ANGEL PLACE
LEVEL 8, 123 PITT STREET
SYDNEY NSW 2000

26 April 2019

CHATSWOOD CHASE DA 2017/503 - SNPP REQUEST FOR INFORMATION

APPENDIX A – AMENDED DESIGN REPORT & PLANS

HAVILAH STREET SCREEN PLANTING

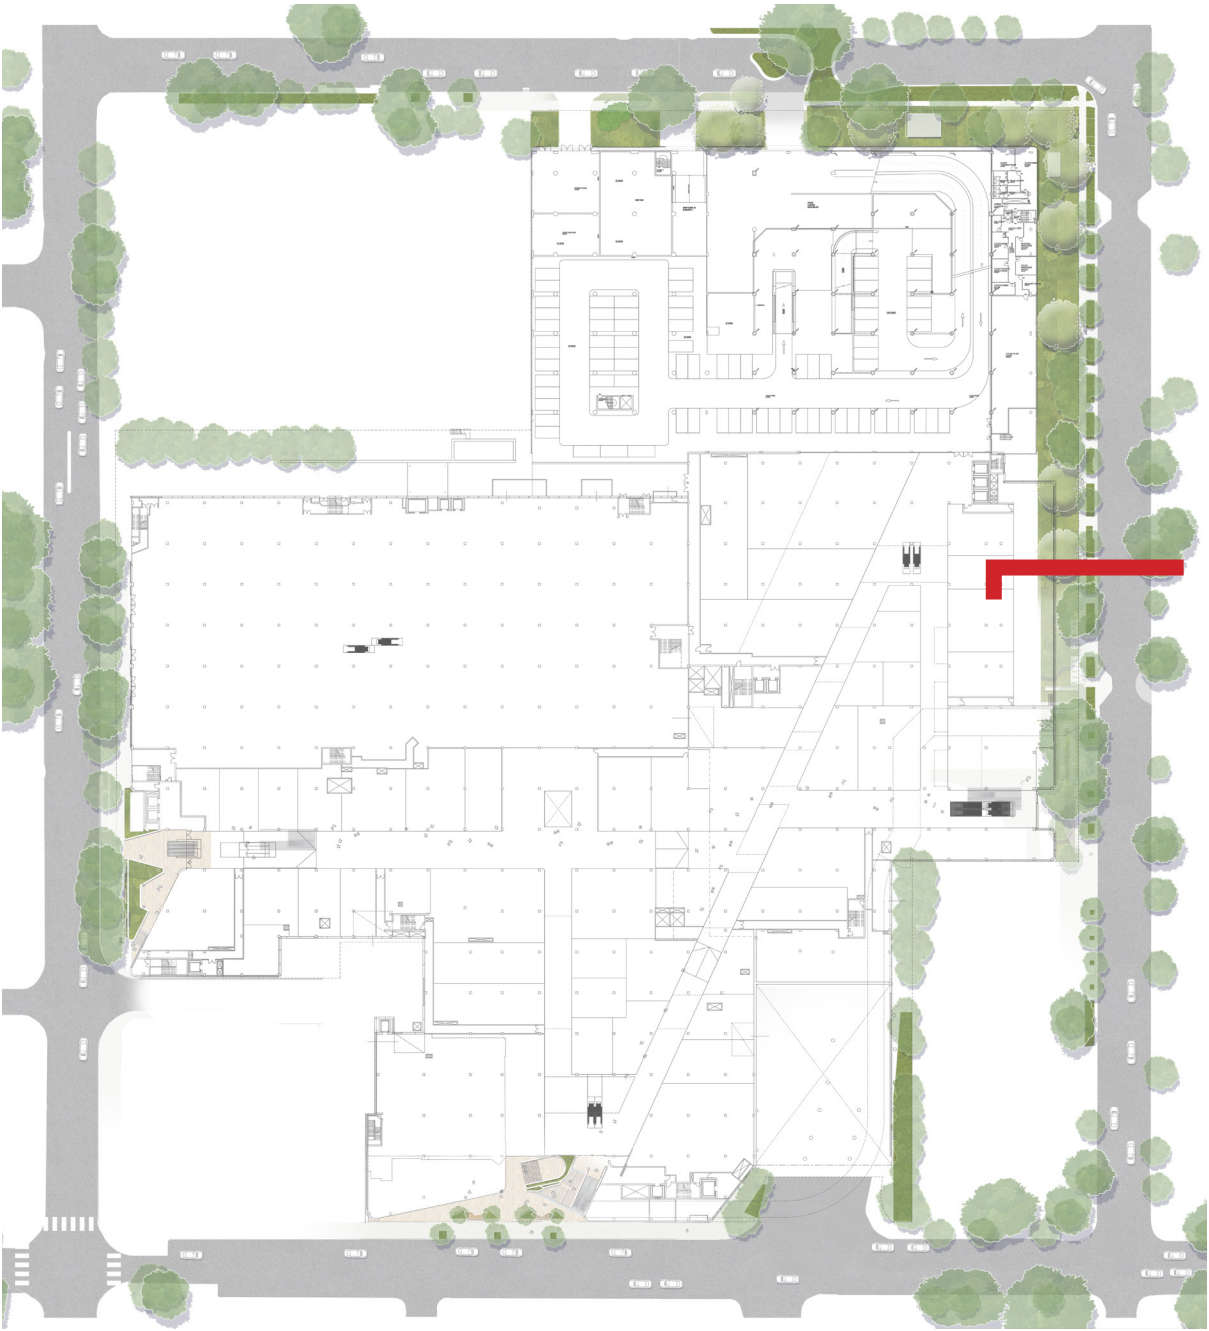
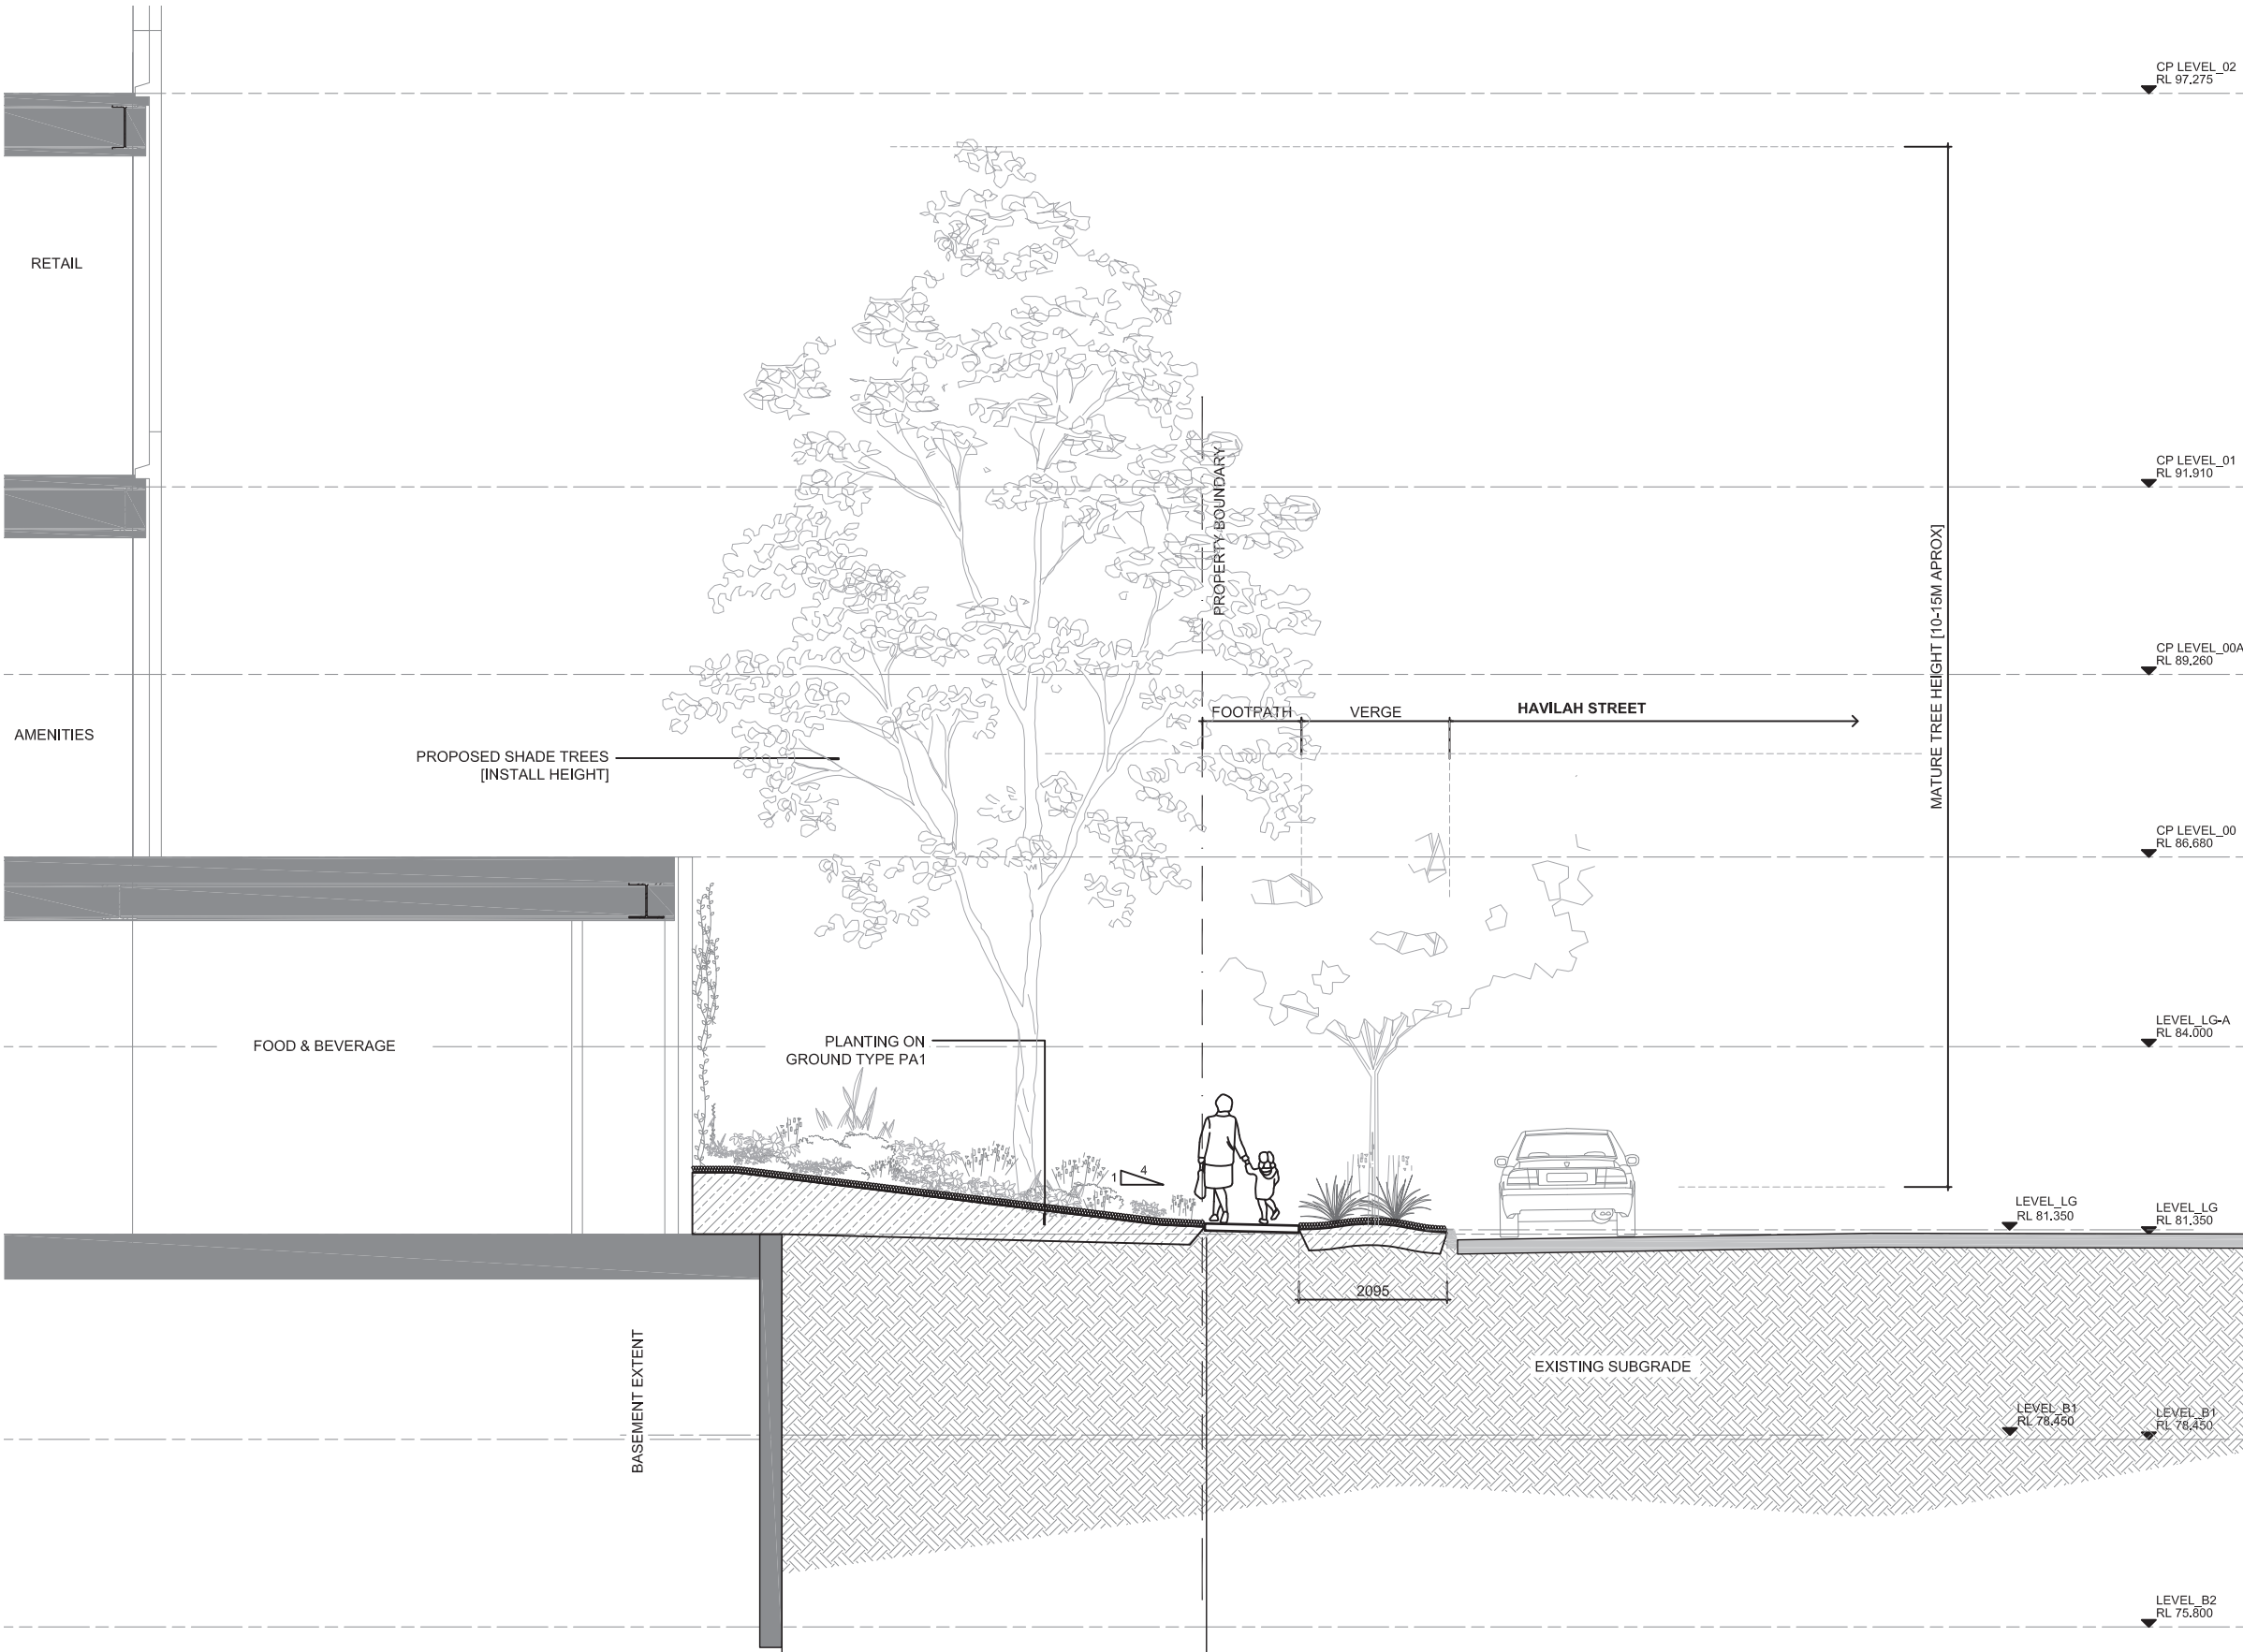
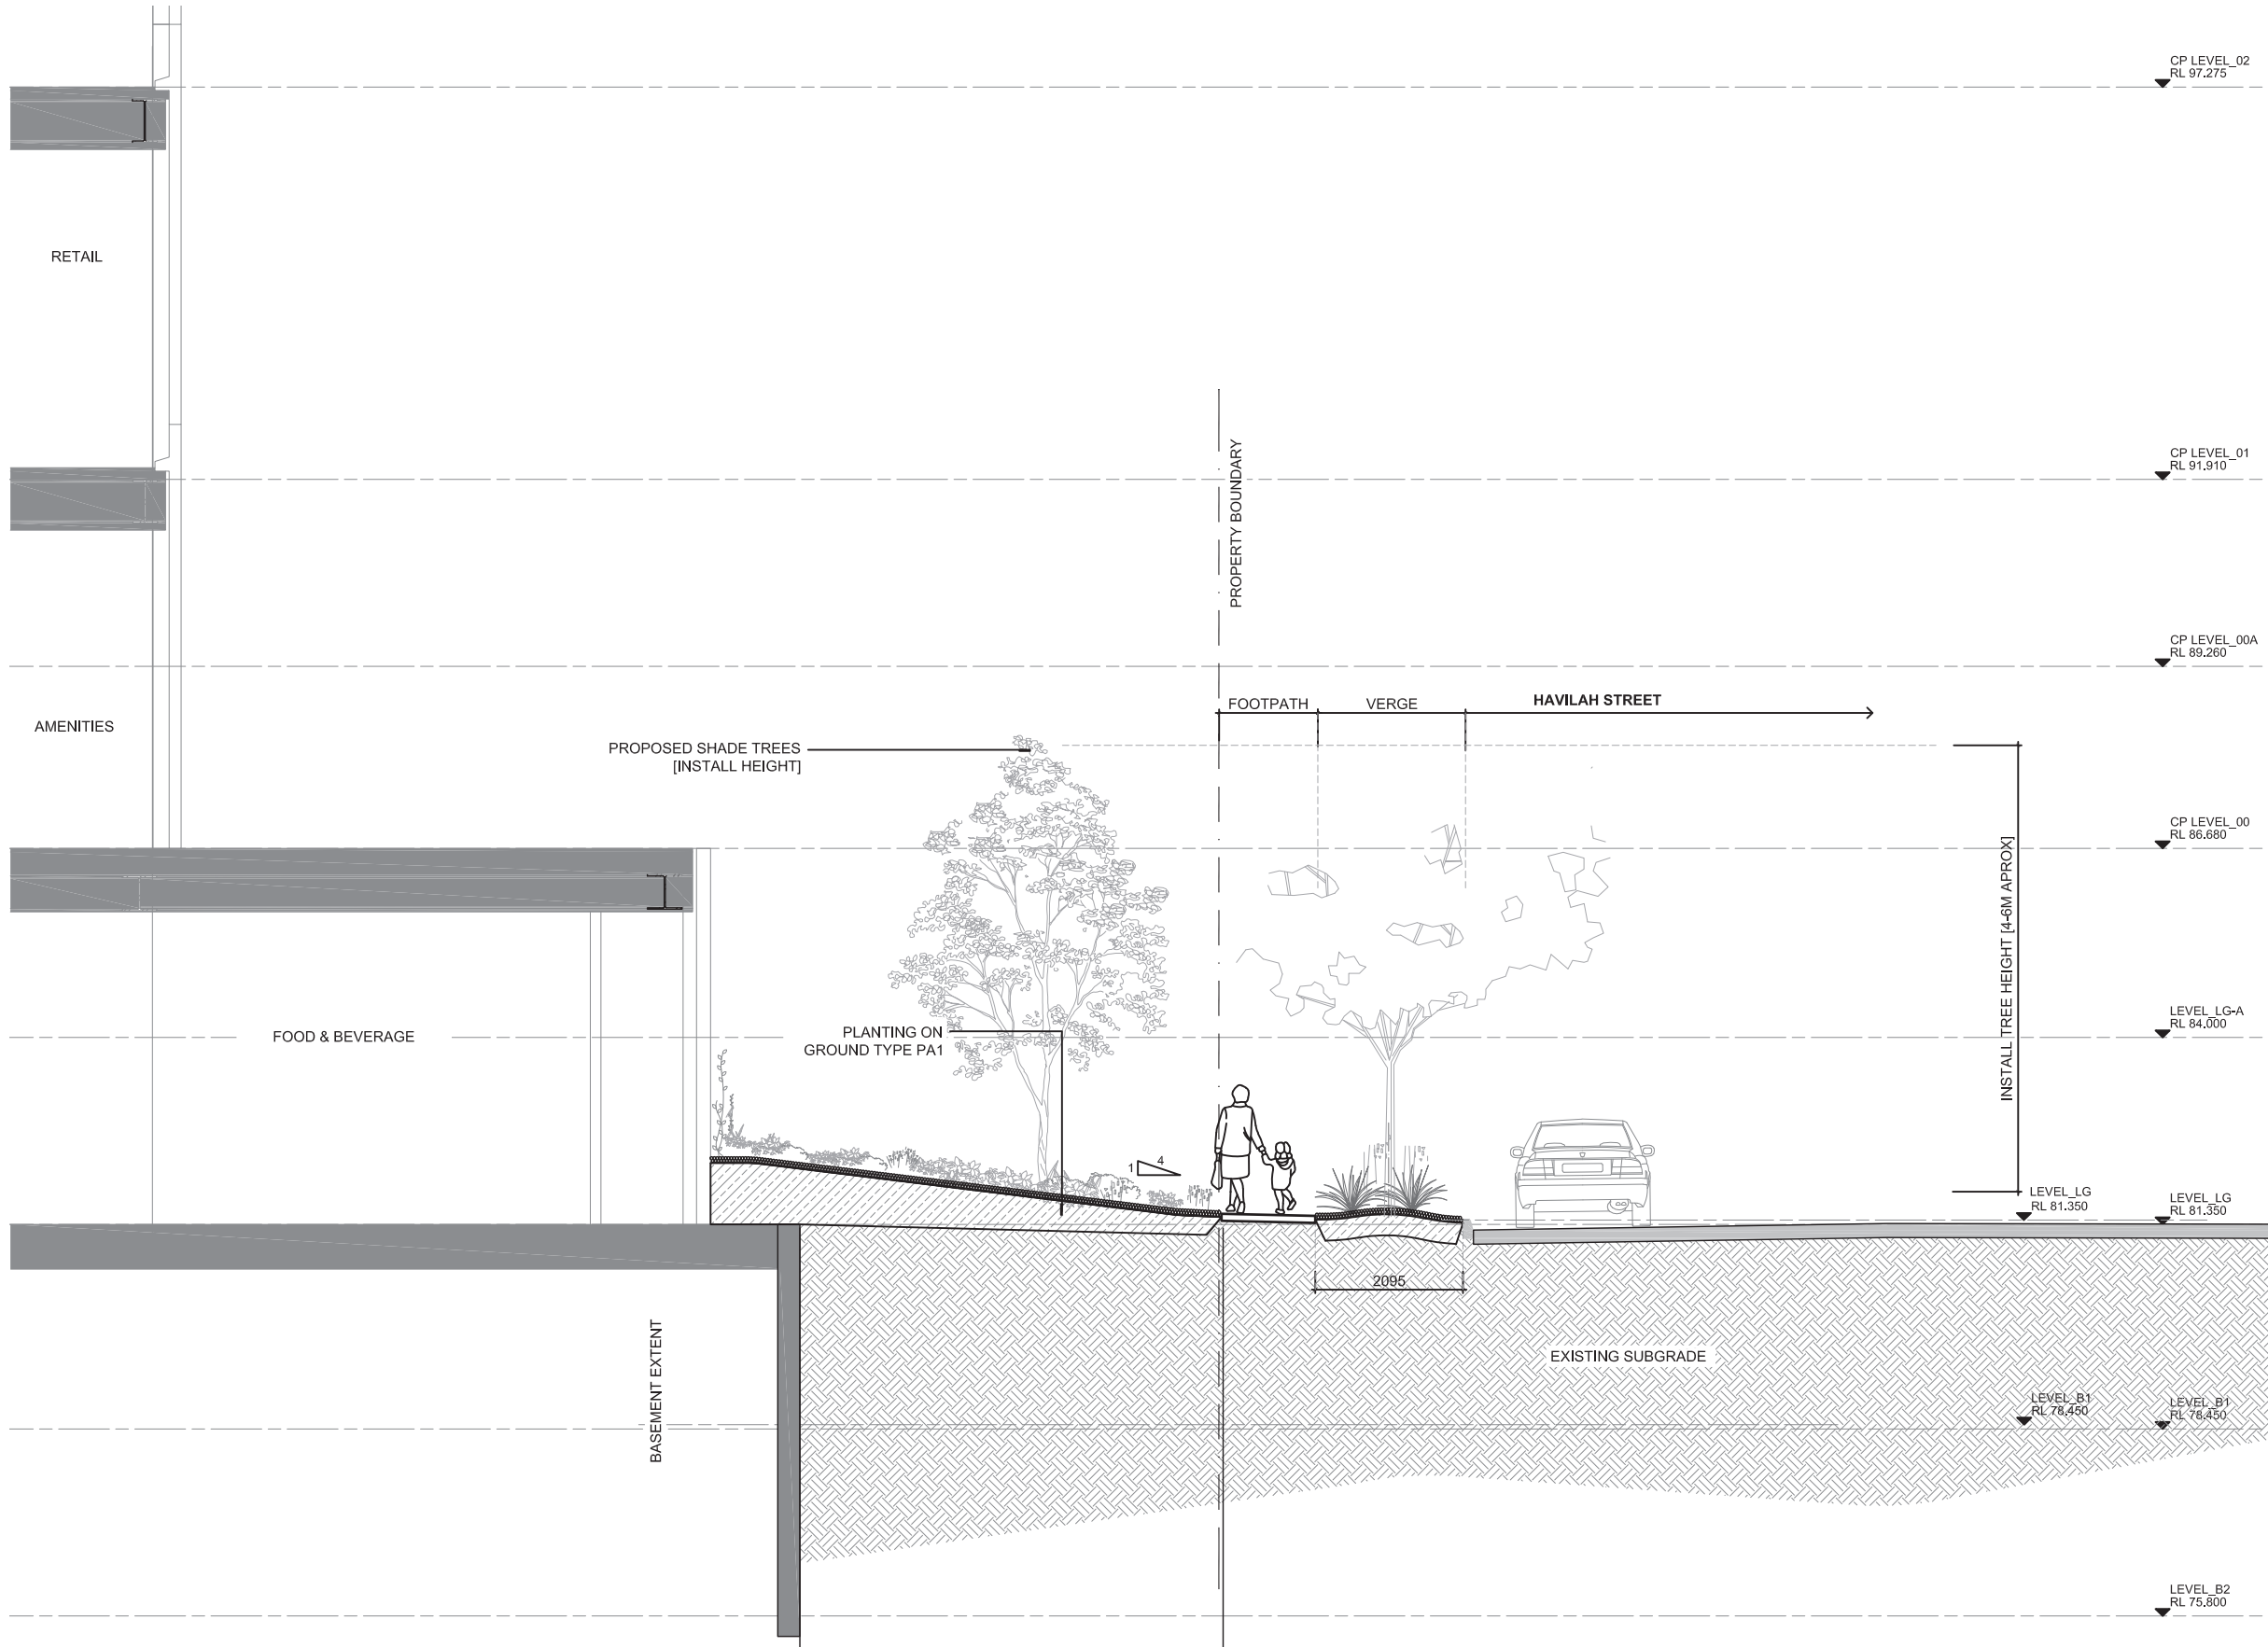
- Revised landscape detail by Lat27 at **Appendix B** that clarifies the species of trees and general greening of development along the Havilah Street frontage.
